NUMBER: 25-002-15 REV. B

GROUP: Emissions Control

P0455/P0456 Set In The Powertrain Control Module (PCM)

2015	(WK)	Jeep Grand Cherokee
2015	(WD)	Dodge Durango

Fig. 1 Split Purge Valve Hose

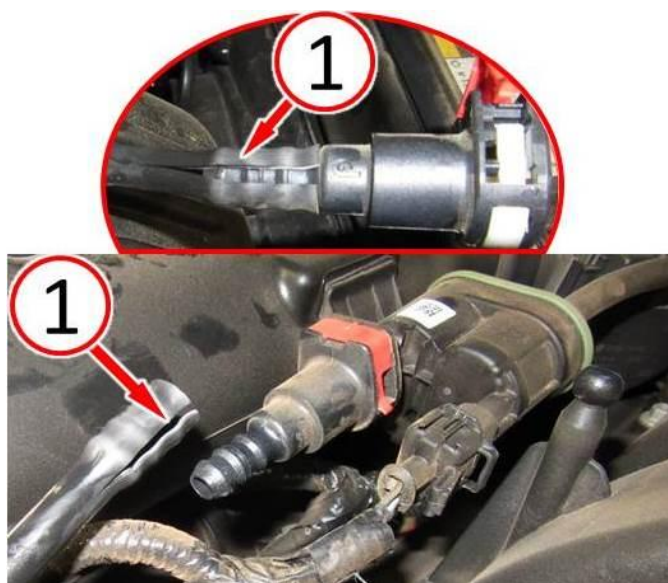
This bulletin involves replacing the evaporative emissions purge valve hose due to a split in the hose that will prevent the system from sealing.

1. **Is vehicle's VIN on the active RRT VIN list?
 - a. YES>>> Proceed to [Step #4](#).
 - b. NO>>> Continue with [Step #2](#).
2. Inspect the purge valve hose for any splits as shown in ([Fig. 1](#)).
3. Were any splits in the purge valve hose found?
 - a. YES>>> Proceed to [Step #4](#).
 - b. NO>>> This Bulletin does not apply. Normal diagnosis should be performed.**

4. Replace the purge valve vapor hose with a new hose. Refer to the detailed service procedures available in DealerCONNECT> TechCONNECT under: Service Info> 25 - Emissions Control, Evaporative Emissions> Lines> Removal/Installation.
